CITY OF OLYMPIA
MULTI-FAMILY RESIDENTIAL
Chapter 18.170

LEFT ELEVATION

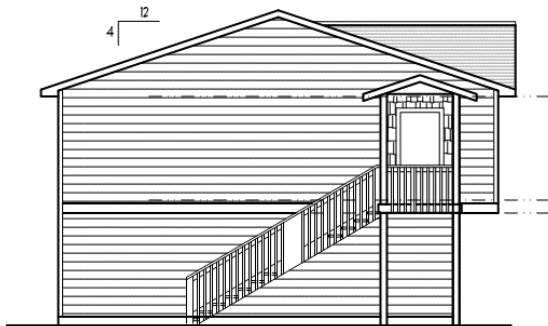
The building is visually modulated in the design of the individual units – the east facade. The gabled roof overhang of each unit, Juliet balconies, and the second story overhang add to the depth and variation in the front façade plane. The south façade, that facing 11th Avenue appears to be a flat plane. As this is the building's frontage, significant efforts should be made to enhance the design on this façade.

- Add modulation or architectural elements that add depth to the building's south façade, the wall facing 11th Avenue to ensure it is clearly the buildings frontage.
